RE: Takes of Marine Mammals Incidental to Specified Activities; Taking Marine Mammals Incidental to a Wharf Construction Project

RE: Proposed Incidental Harassment Authorization, Naval Base Kitsap-Bangor

RE: Takes of Marine Mammals Incidental to Specified Activities; Taking Marine Mammals Incidental to a Wharf Construction Project; Notice (79 FR 32827, June 6, 2014)

The Marine Mammal Commission (the Commission), in consultation with its Committee of Scientific Advisors on Marine Mammals, has reviewed the U.S. Navy's application seeking authorization under section 101(a)(5)(D) of the Marine Mammal Protection Act (the MMPA) to take marine mammals by harassment. The taking would be incidental to pile driving and removal in association with a wharf construction project in Hood Canal at Naval Base Kitsap in Bangor, Washington. The authorization would be in effect from 16 July 2014 to 15 July 2015. The Commission also has reviewed the National Marine Fisheries Service's (NMFS) 6 June 2014 notice (79 Fed. Reg. 32828) announcing receipt of the application and proposing to issue the authorization, subject to certain conditions. The Commission has commented on previous incidental harassme

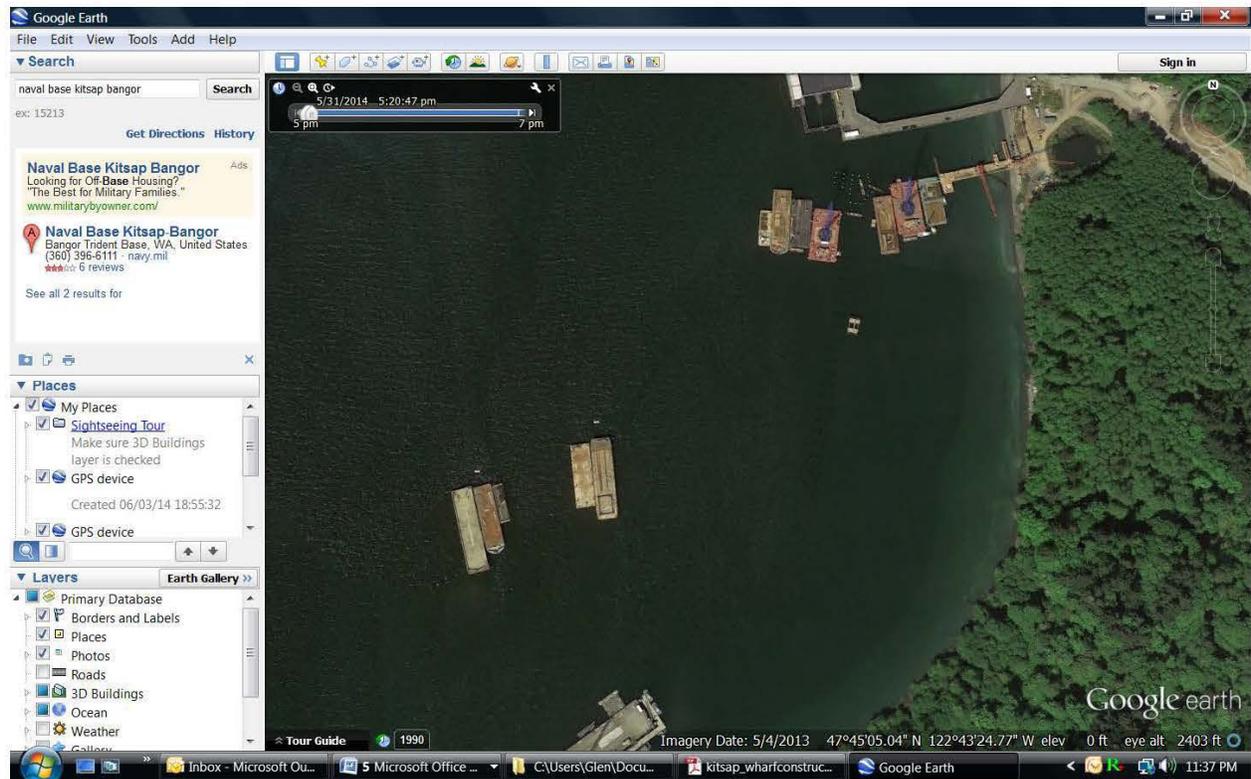
However, the Navy has violated its own EIS and past IHAs by leaving equipment and hardware in the water outside the in-water work window, during the period from mid-February to mid-July. The Navy never addresses effects from its project outside of the approved in-water work window.

The Navy must either remove all construction equipment out of Hood Canal during the period outside the approved work window or assess the impact of this equipment in its application for an IHA.

Please see the attached photo from Google Earth. The photo was taken May 4, 2013, outside the approved work period. Please notice that there are two cranes and at least eight barges in the water at this time. Not only is this activity outside the Navy's application for the year, the Navy has not assessed the impact of this construction equipment.
